Meeting Notes Speed Table

2.2/2.6/2.7/2.8

Figure 1

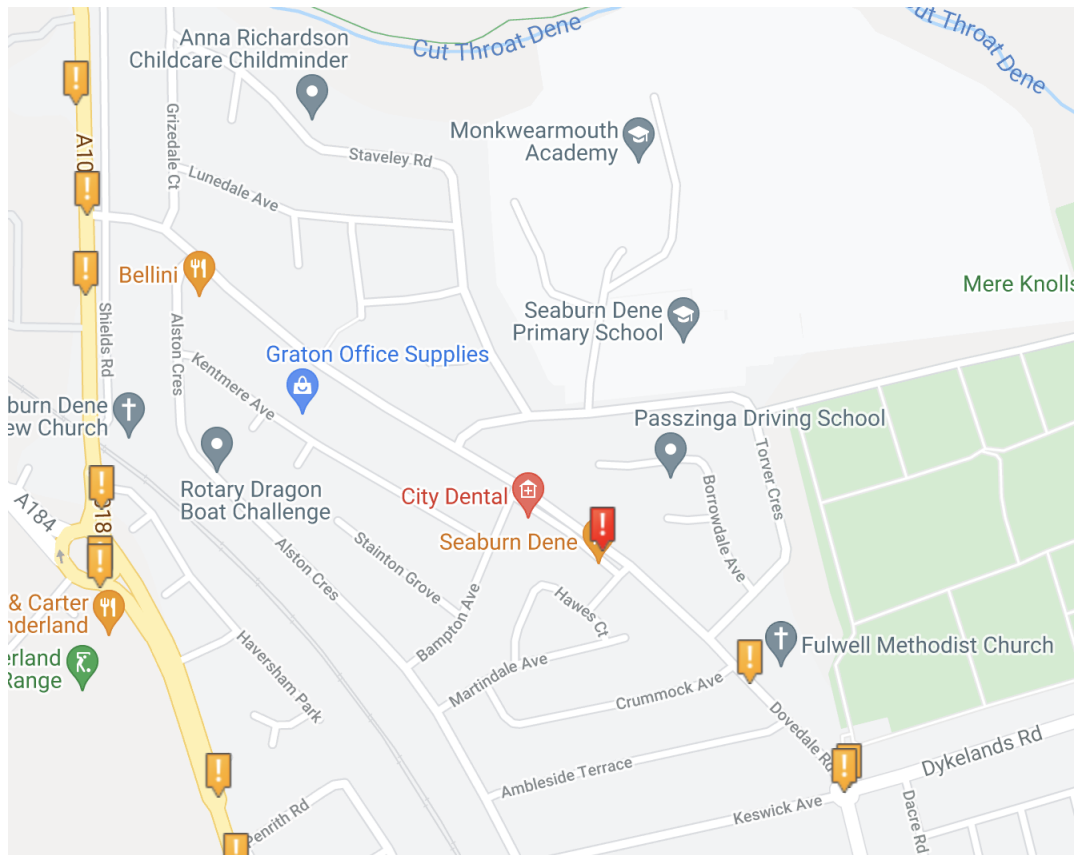
The councils defence of this proposal appears to be reliant on increasing safety around the crossing area on Dovedale road. Figure 1 provided from CrashmapUK (data provided by the department of transport) shows the crash locations on Dovedale Road for the past 5 years.

In this time period 5 accidents occurred, one at the intersection with shields road, two at the roundabout with Dykelands road, one near the intersection with Crummock Avenue and one near the Dovedale bus stop towards the entrance to Hawes court. Crucially there has not been a single accident at the crossing point near Torver Crescent suggesting the current measures of two traffic wardens at peak times are adequate.

Figure 2

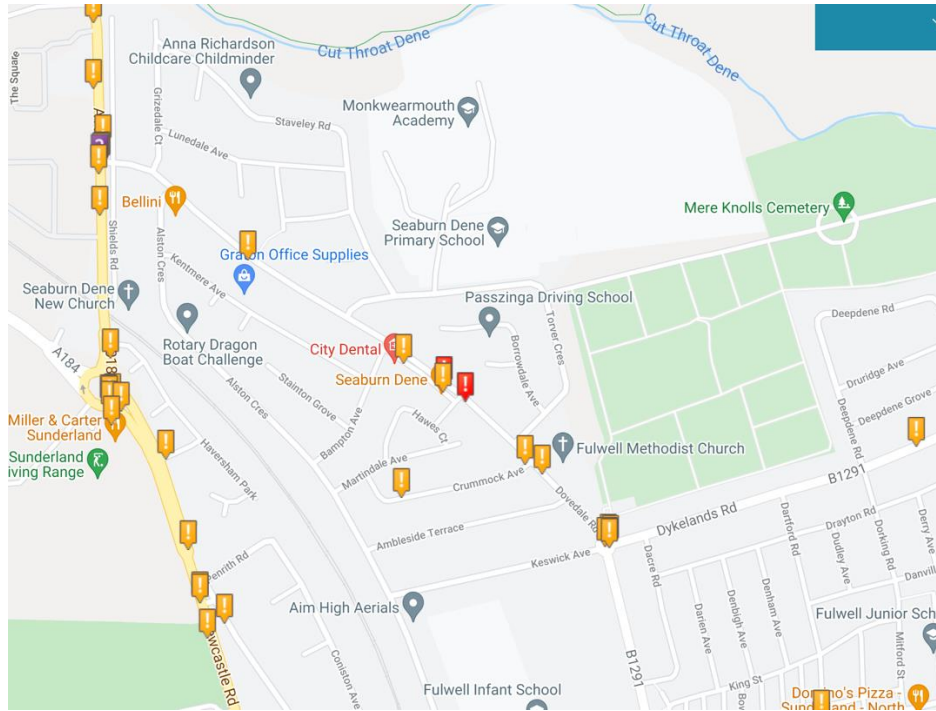
To further illustrate this point, Figure 2 provides the crash locations for the past 10 years.

In this time period 5 accidents occurred, 4 at the intersection with shields road, 5 at the roundabout with Dykelands road, one near the intersection with Crummock Avenue and 4 near the Dovedale bus stop towards the entrance to Hawes court. This further illustrates there has not been a single accident at the crossing point near Torver Crescent suggesting the current measures of two traffic wardens at peak times have been and remain to be effective. As such a 16m speed table near the centre of a approximately 1km long road would be ineffective in impacting the danger areas of the road at the busy intersections and does not improve ‘expeditious, convenient and safe movement of vehicular or other traffic’ and therefore does not fulfil the requirements under section 122 of the road traffic and regulation act 1984.

Figure 3

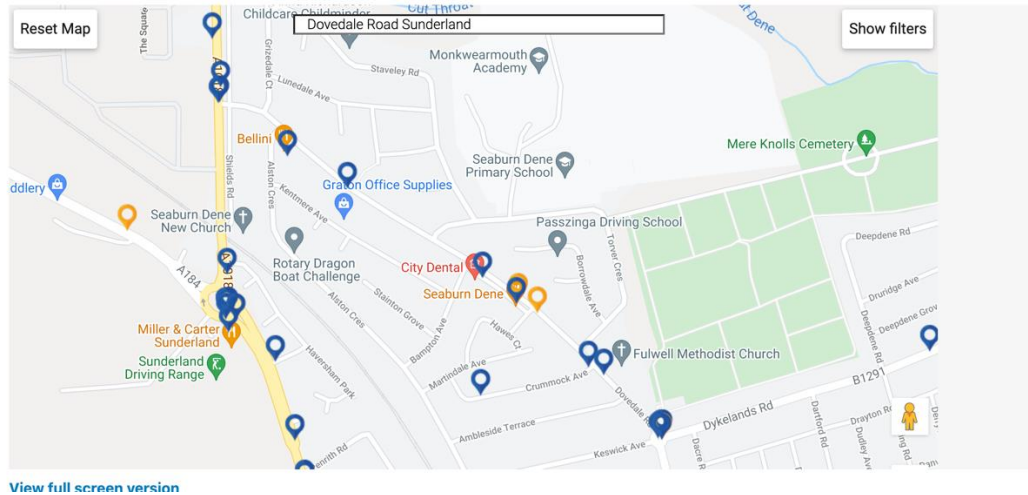
I have attached a third figure from ThinkUK to further demonstrate my point.
